Convention on Road Signs and Signals (1968)

Amendment proposals to the 1968 Convention on Road Signs and Signals

Revision

Submitted by Lithuania and Luxembourg

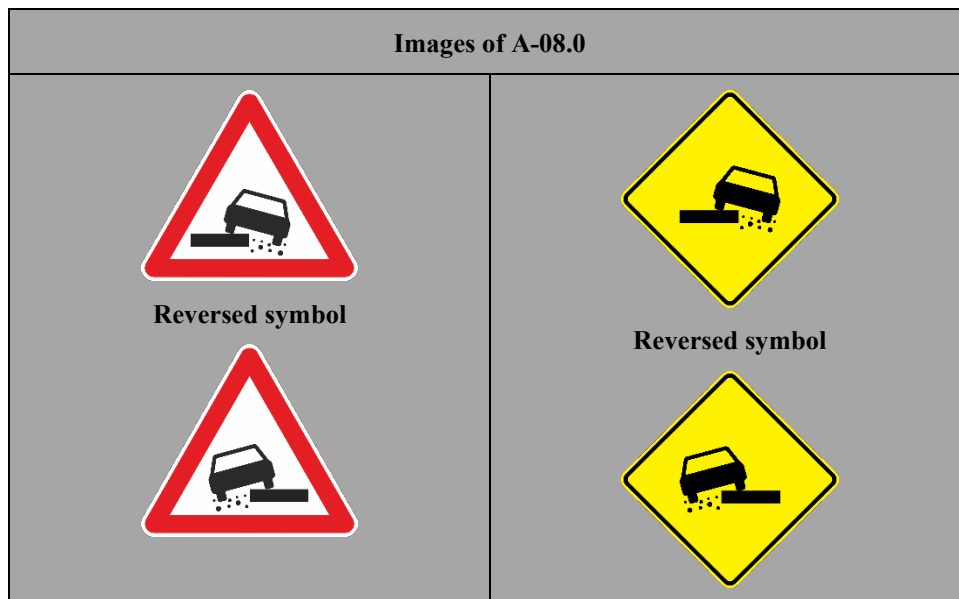
~~(b) The symbol may be reversed.~~

A-08.0 gives warning of a section of road where the shoulders are particularly dangerous. The symbol on this sign may be reversed.

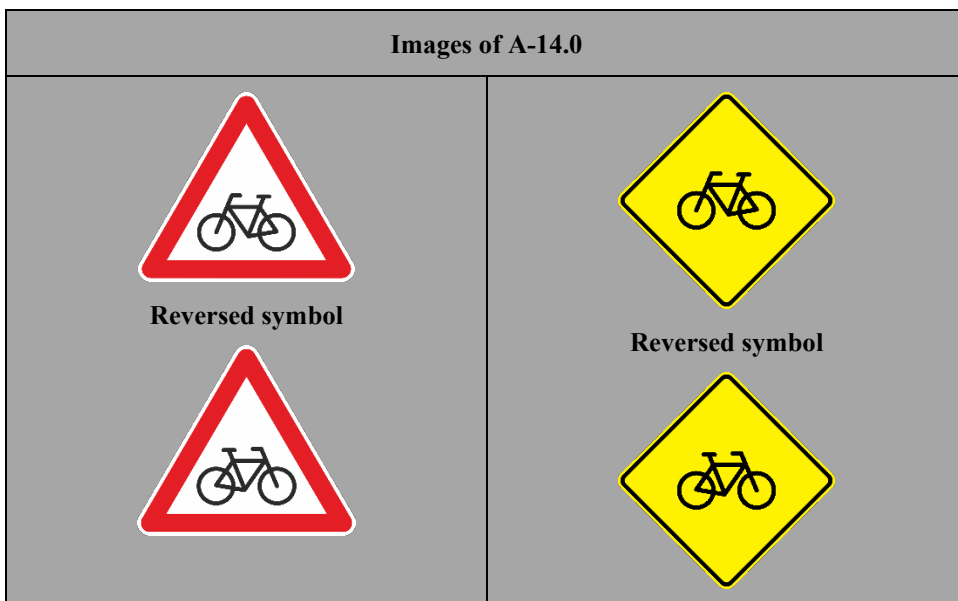
(b) ~~The symbol may be reversed.~~

A-14.0 gives warning of a point at which cyclists frequently enter or cross the road. The symbol on this sign may be reversed.

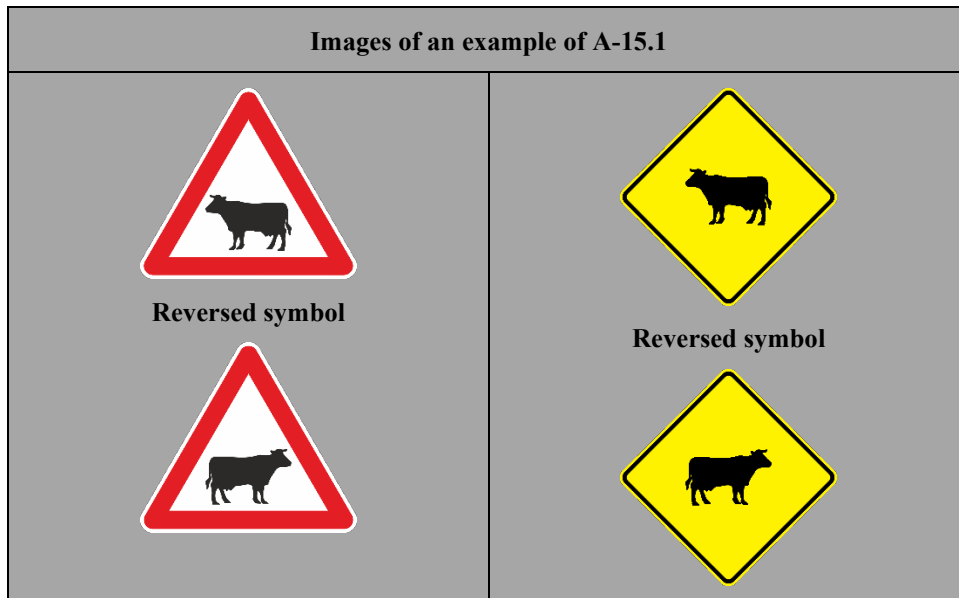
(b) ~~The symbol may be reversed.~~

A-15.1 gives warning of a section of road on which there is a particular danger of domestic animals crossing. The symbol shall represent the silhouette of the domestic animal most frequently encountered. The symbol on this sign may be reversed.

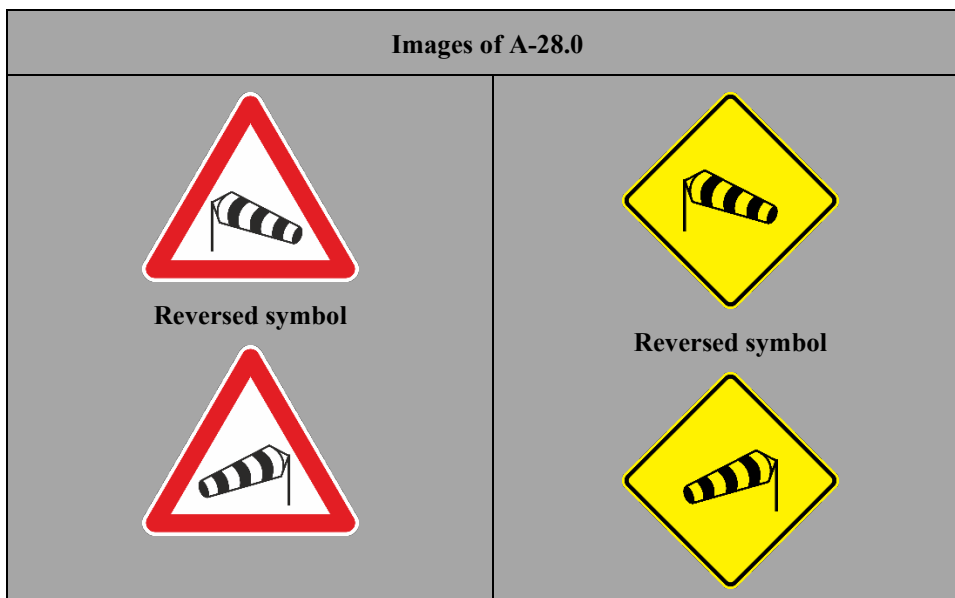
(b) ~~The symbol may be reversed.~~

A-28.0 gives warning of a section of road on which there is often a strong cross-wind. The symbol on this sign may be reversed.

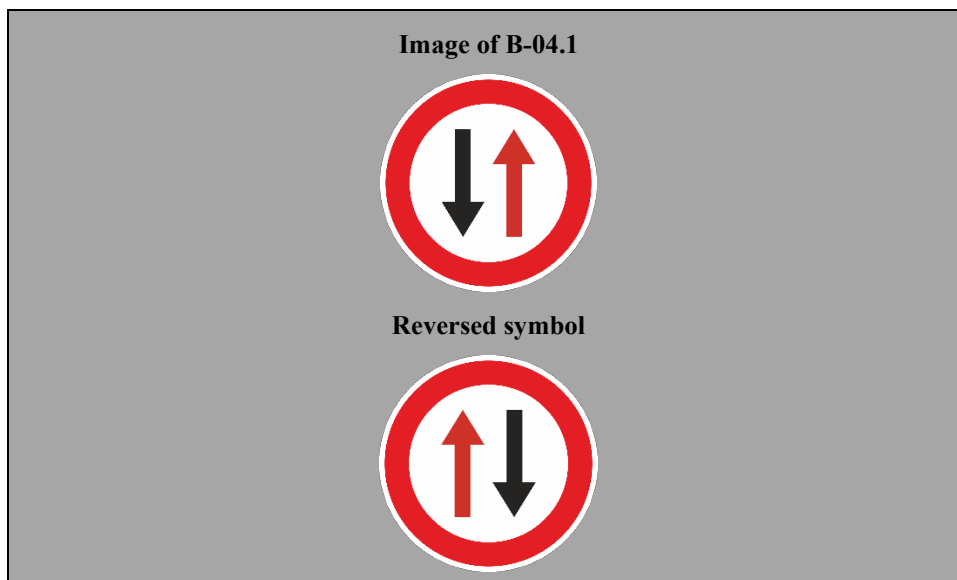
(b) This sign shall be round, with a white or yellow ground and with a red border; the arrow indicating the direction having priority shall be black and that indicating the other direction red. **The arrows shall be parallel.**

COMPULSORY ROUNDABOUT

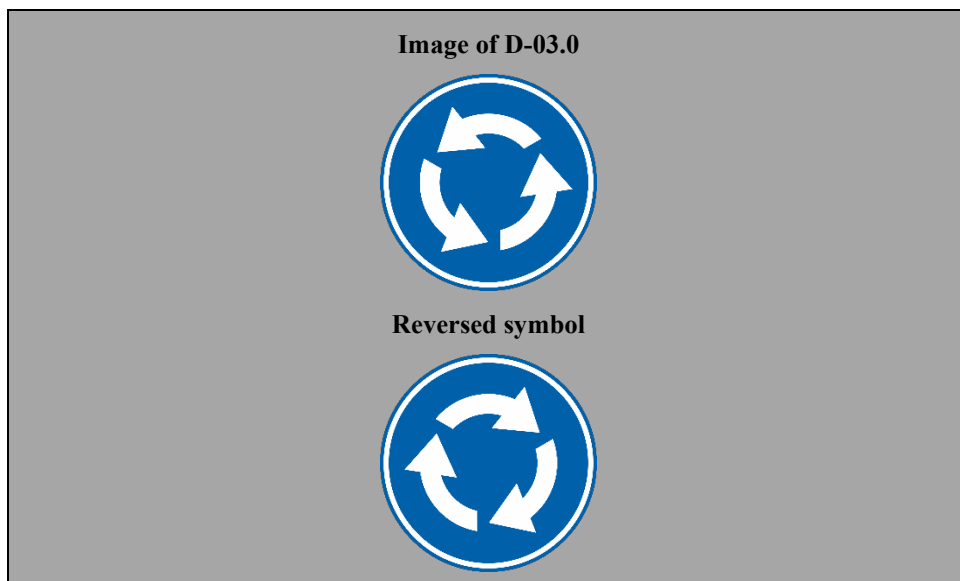
~~3. Sign D, 3 D-03.0 'COMPULSORY ROUNDABOUT', shall notify that~~ **vehicles must follow** the direction at the roundabout indicated by the arrows. If the **compulsory** roundabout is indicated by the sign ~~D, 3 D-03.0~~ together with the sign ~~B, 1 B-01.0~~ or ~~B, 2 B-02.0~~, the ~~driver vehicle~~ in the roundabout has priority. **The symbol on this sign shall be reversed for traffic keeping to the left.**

PEDESTRIAN CROSSING

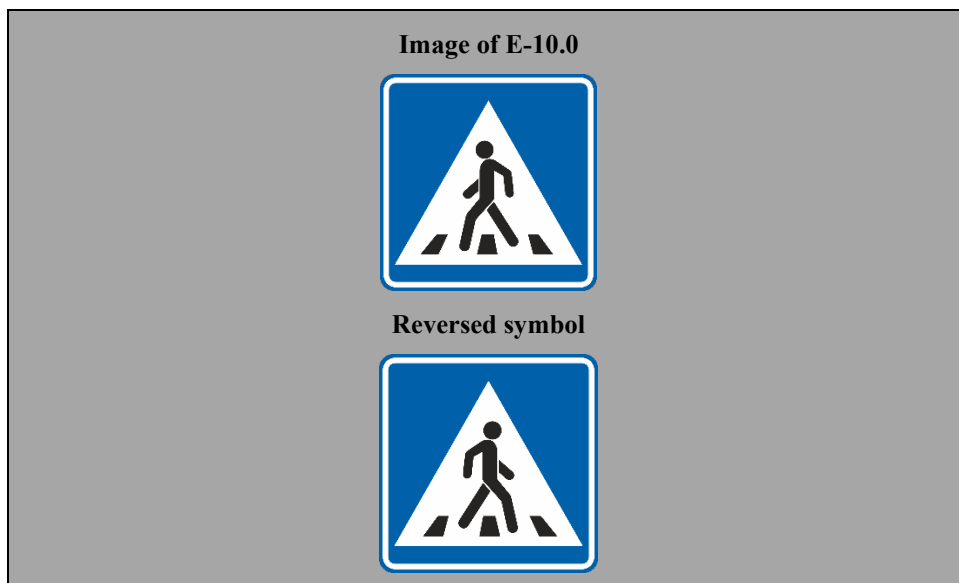
(a) ~~Sign E, 12 a, "PEDESTRIAN CROSSING", E-10.0 notifies road users of~~ is used to show pedestrians and drivers the position of a pedestrian crossing. The ground of ~~the panel this sign~~ shall be blue or black with the triangle a white or yellow triangle. ~~and~~ The symbol shall be black or dark blue. ~~;~~ the This symbol shall symbol displayed shall be a pedestrian on a crossing marked by broad stripes. symbol as A, 12 a (A 12.1). The symbol on this sign may be reversed.

BREAKDOWN SERVICE

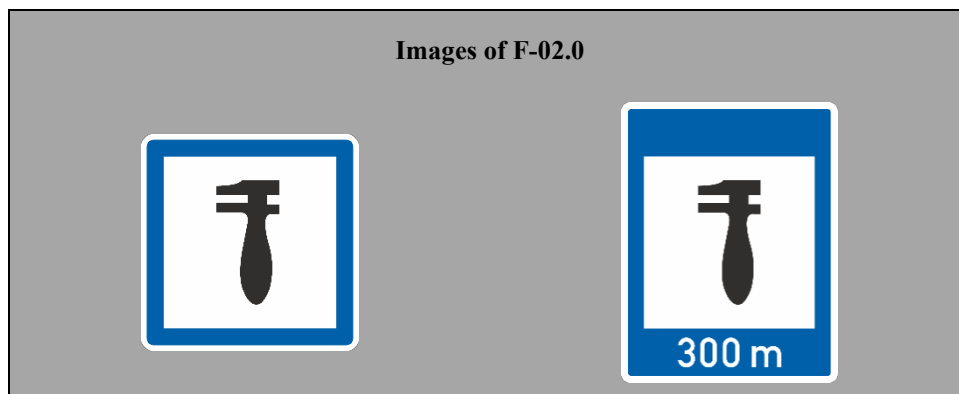
~~F, 2 "BREAKDOWN SERVICE"~~ **F-02.0 notifies of a location of a breakdown service.**
